Well Name: POKER LAKE UNIT 19 DTD	Well Location: T24S / R30E / SEC 19 / NWNE /	County or Parish/State:
Well Number: 321H	Type of Well: CONVENTIONAL GAS WELL	Allottee or Tribe Name:
Lease Number: NMNM002860	Unit or CA Name:	Unit or CA Number: NMNM07016Z
US Well Number: 3001553828	Well Status: Approved Application for Permit to Drill	Operator: XTO PERMIAN OPERATING LLC

Sundry ID: 2777489

Type of Action: APD Change

OPERATOR'S NAME:	XTO Permian Operating LLC
WELL NAME & NO.:	Poker Lake Unit 19 DTD 321H
LOCATION:	Sec 19-24S-30E-NMP
COUNTY:	Eddy County, New Mexico

Form C-102
Revised August 1, 2011
Submit one copy to appropriate
District Office

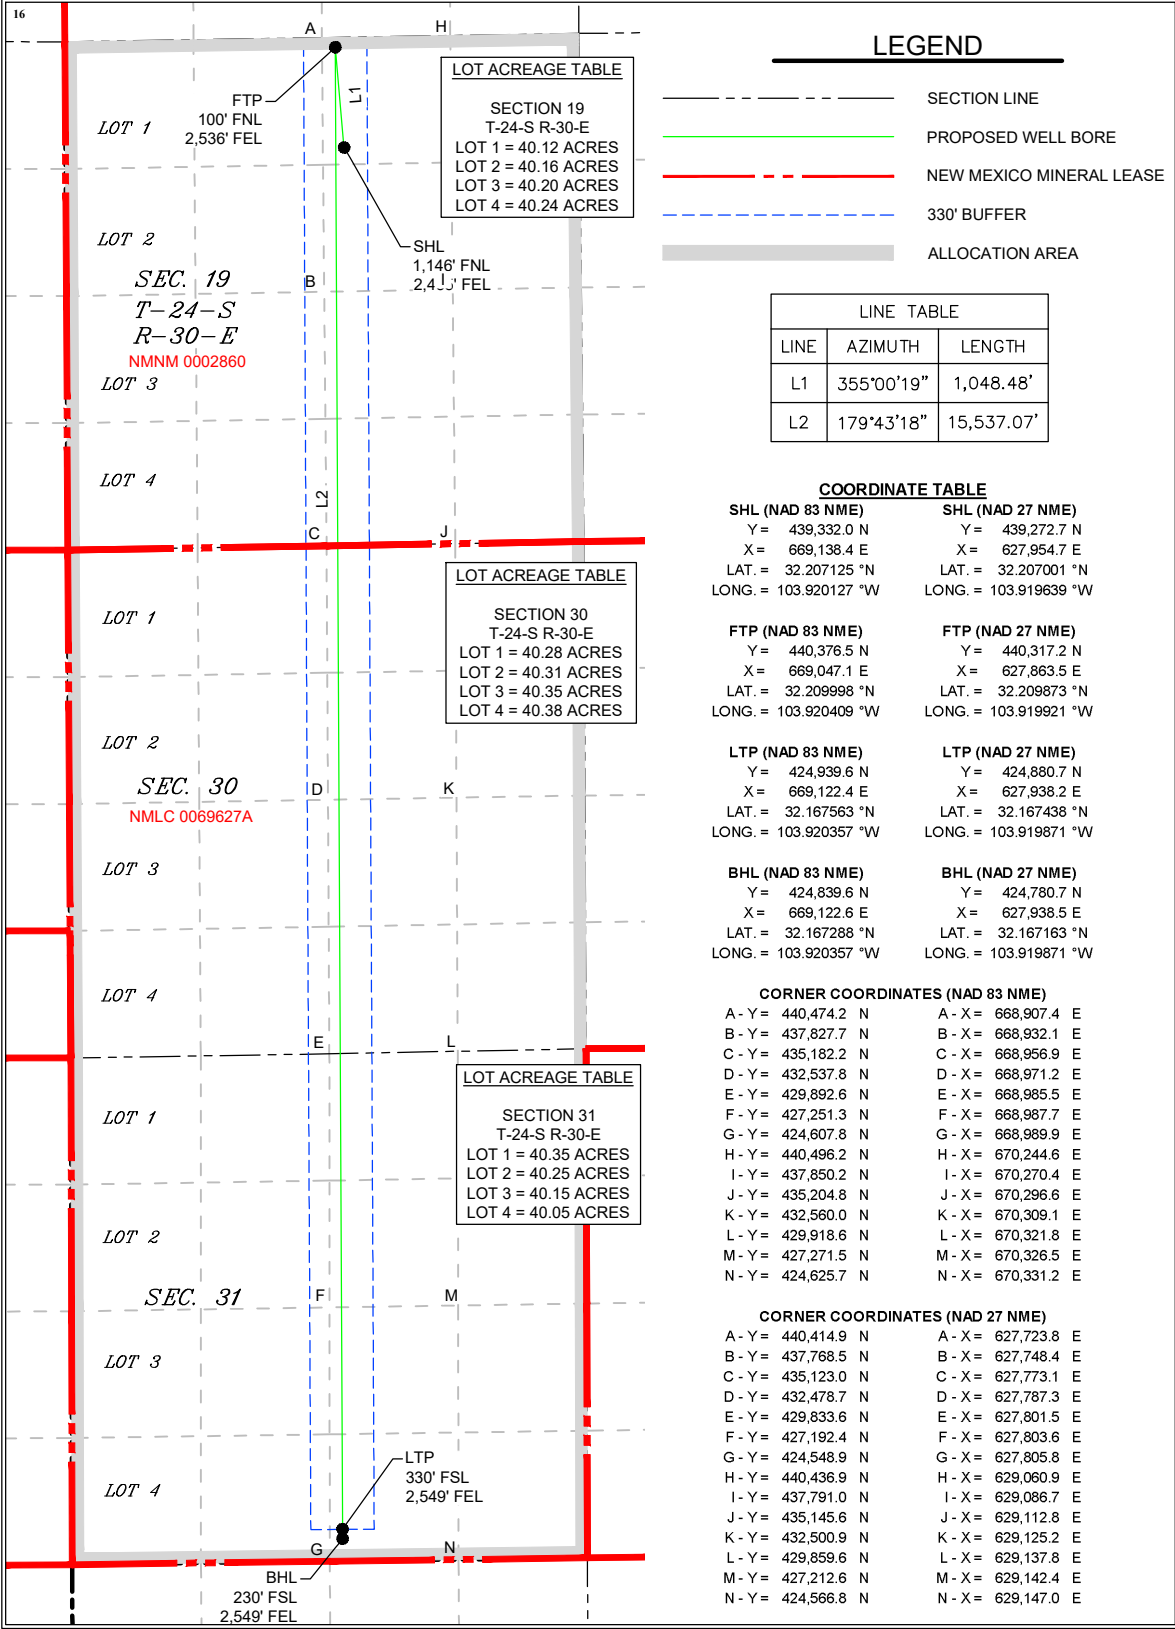
FROM: TO: SHL: 1201' FNL & 2455' FEL of Section 19-T24S-R30E 1146' FNL & 2455' FEL of Section 19-T24S-R30E
FTP: 100' FSL & 2090' FEL of Section 18-T24S-R30E 100' FNL & 2536' FEL of Section 19-T24S-R30E LTP: 2450' FSL
& 2090' FEL of Section 31-T23S-R30E 330' FSL & 2549' FEL of Section 31-T25S-R30E BHL: 2590' FSL & 2090' FWL
of Section 31-T23S-R30E 230' FSL & 2549' FEL of Section 31-T24S-R30E Proposed total depth will change from
29340' MD; 10551' TVD (Wolfcamp) to 26810' MD; TVD 11477' (Wolfcamp). See attached Drilling Plan for updated
cement and casing program. Attachments: C-102, Drilling Plan, Directional Drilling Plan, MBS, BOP Variance, Well
Control Plan
